PROPOSAL FOR DRAFT AMENDMENTS TO REGULATION No. 44
(Child restraint system)

Transmitted by the Expert from Sweden

Note: The text reproduced below was prepared by the expert from Sweden in order to introduce in Regulation 44 a definition of the floor pan on the test trolley described in Annex 6. It supersedes document TRANS/WP.29/GRSP/2000/2.

Figure 1

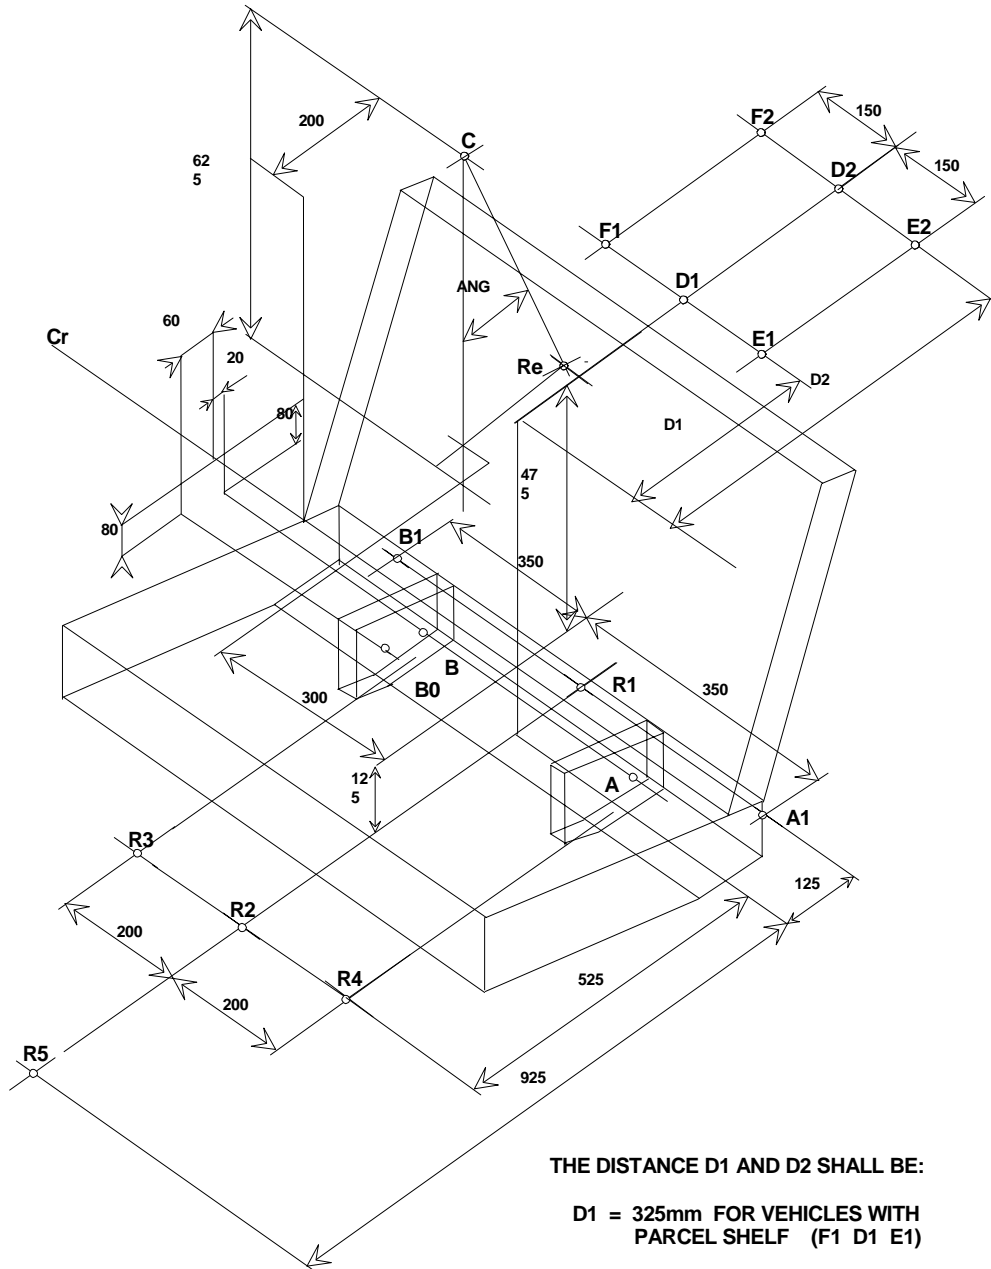
Annex 6 – Appendix 3, Figure 1, replace by the new following figure 1:

THE DISTANCE D1 AND D2 SHALL BE:

D1 = 325mm FOR VEHICLES WITH
PARCEL SHELF (F1 D1 E1)

D1 = 1025mm FOR VEHICLES WITH
FOLDING BACK REAR SEATS
(ESTATE TYPE) (F2 D2 E2)

DIMENSIONS REFERRING TO Cr
ARE TOLERANCED WITH: ± 2 mm
EXCEPT FOR DISTANCE FLOOR TO Cr ± 10 mm

DISTANCE C - Re = 550mm
ANGLE "ANG" = 30° MAXIMUM

Figure 2

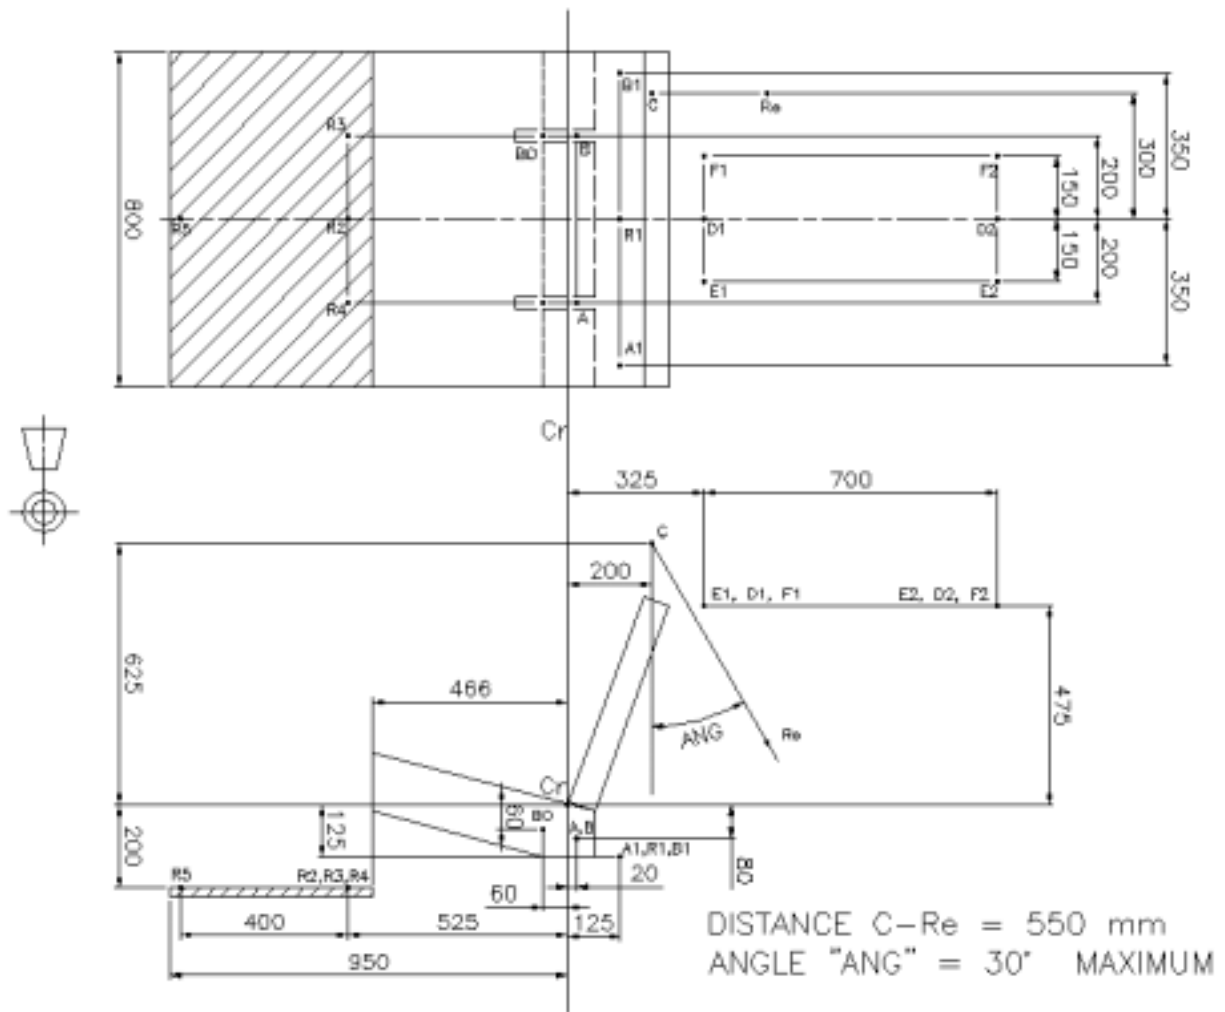
- 3.3 Trolley floor pan
- 3.3.1. The floor pan of the trolley shall be constructed of a flat sheet of metal of uniform thickness and material , see Figure 2 of appendix 3 to this annex.

Annex 6 – Appendix 3, Figure 2, replace by the following new figure 2:

FLOOR AREA IS HATCHED
